TEXAS COMMISSION ON ENVIRONMENTAL QUALITY

CLASS 3 COMPLIANCE PLAN MODIFICATION
TO
COMPLIANCE PLAN NO. 50236
SAFETY-KLEEN SYSTEMS INC - MISSOURI CITY

Subject: Plugging & Abandonment of Monitoring Well MW-12
Safety-Kleen Systems, Inc., Missouri City Facility
1580 Industrial Drive, Missouri City, Texas
TCEQ ID No.: 71144, TCEQ Compliance Plan No. CP-50236
EPA ID No.: TXC0108003203

Site Plan

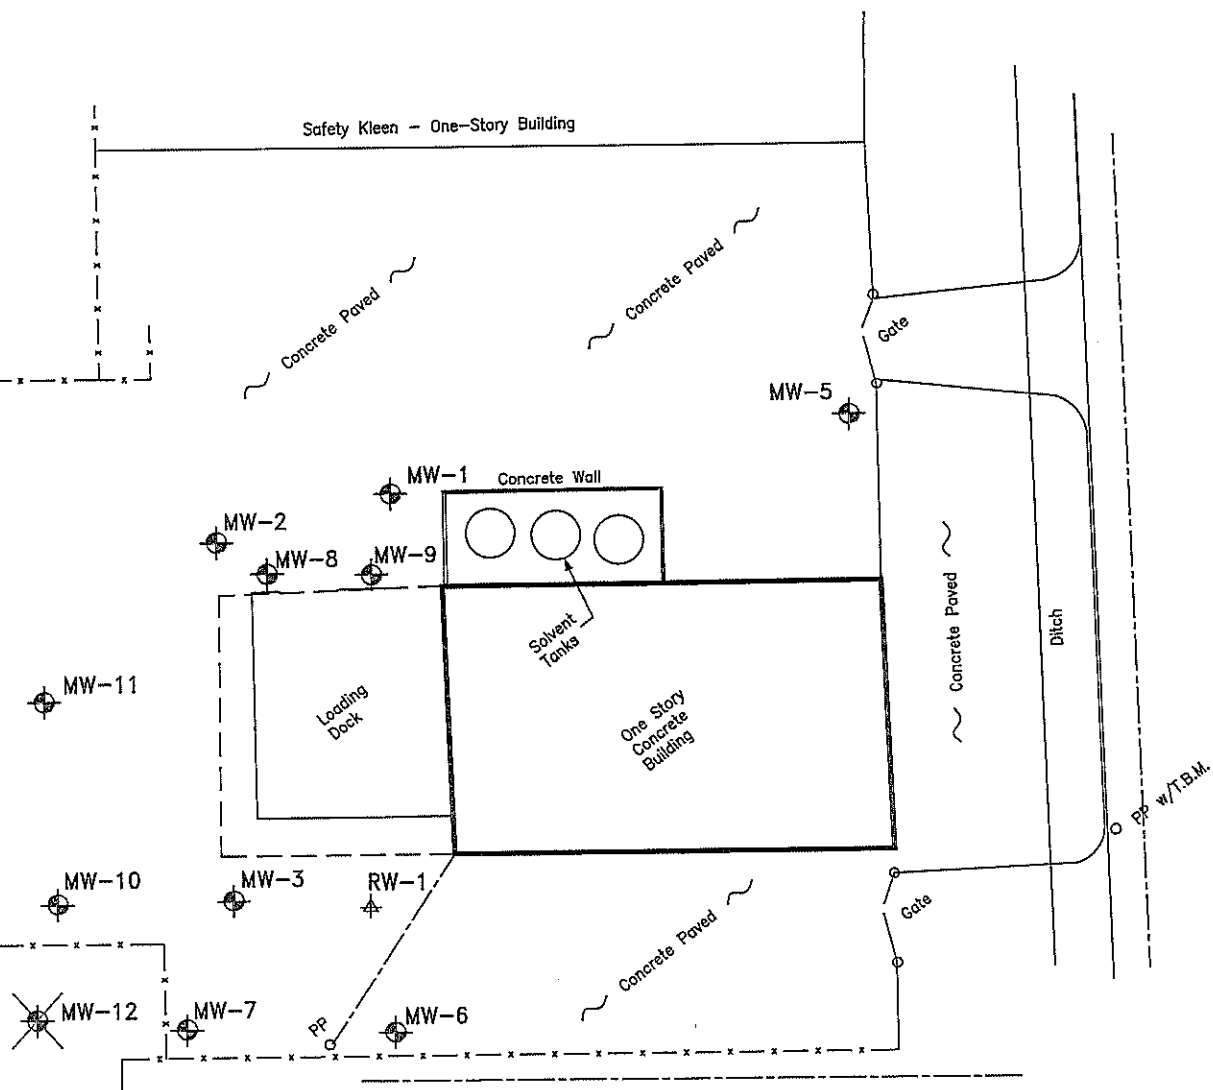
NOTE: Monitoring Well MW-12 Plugged On January 21,2011

Photo 1 – View of RW-1 prior to removal of hoses and wires associated with former remediation system.

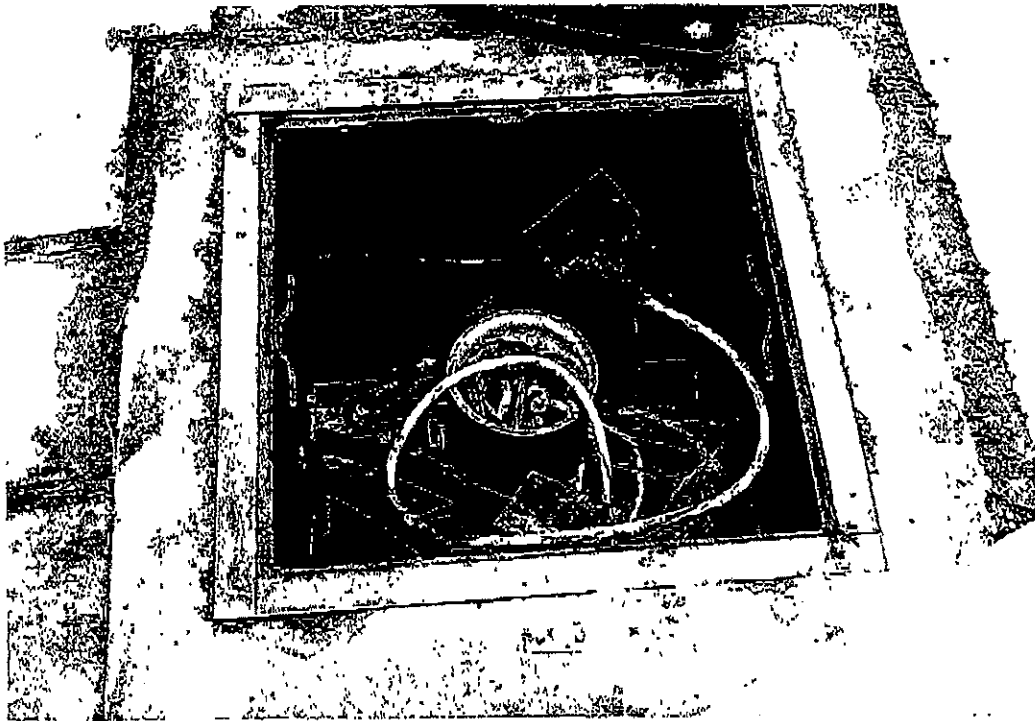
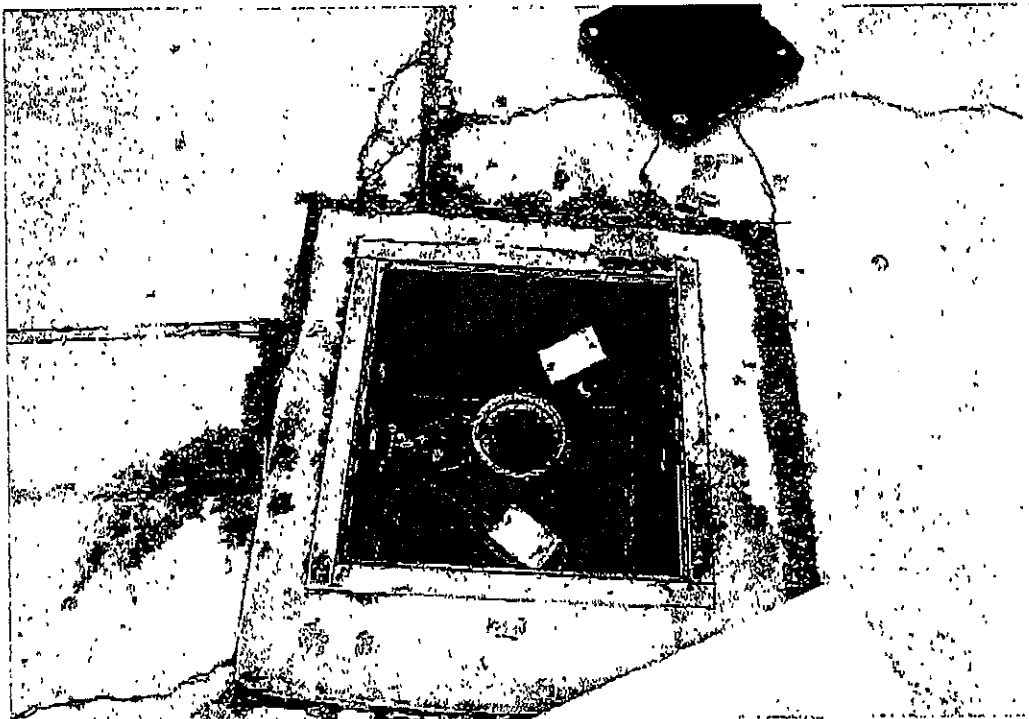
Groundwater elevation maps prepared for recent sample events appear to show an anomalous rise in well RW-1. This rise appears to have occurred one time prior to the July 2009 event, when an approximate two foot rise above the other monitoring wells was measured during the July 2007 sample event. In the current sample event, the wells showed an approximate 6.22 foot rise above the other wells.

The September 23, 2010 facility response stated that the RW-1 well vault will be removed and replaced with a concrete pad and new manhole cover. Documentation of this corrective action will be submitted to the TCEQ upon completion. This additional issue will be resolved upon receipt of documentation of the corrective action.

The February 9, 2011 submittal documents that the vault has been removed and replaced with a concrete pad with appropriate cover. The additional issue is considered resolved.
